SERVICE BULLETIN

Number: SB0301

Subject: New Brake Rod Assy

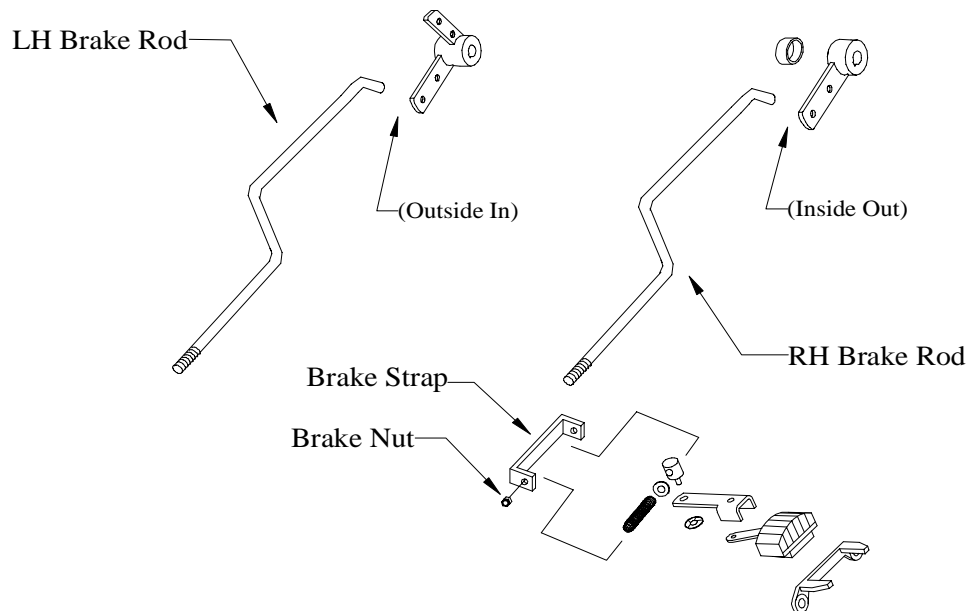
The above diagram displays the new Brake Rod Assy now being installed on the Prowler Series Riders. The Brake Strap and Brake Nut replace the 5/16" nyloc nut and the 5/16" clamp collar (part # 523112). The 5/16" flat washer is replaced by a 5/16" SAE Washer (part # 105257). Note that the 5/16" SAE Washer is now located **between** the brake spring (part # 523024) and the park brake swivel (part # 423130).

Existing brake rod assy's may be retro-fitted with the new assy design. This replacement may be performed by purchasing the following components:

*** When performing this changeover, it is recommended that the brake rod assy be removed from the machine by removing the 3/8" push nut from the park brake swivel and disconnecting the brake rod from the brake crank (note the direction the brake rod connects to the brake crank as shown in diagram) and re-assembling with new components before re-installing onto machine.
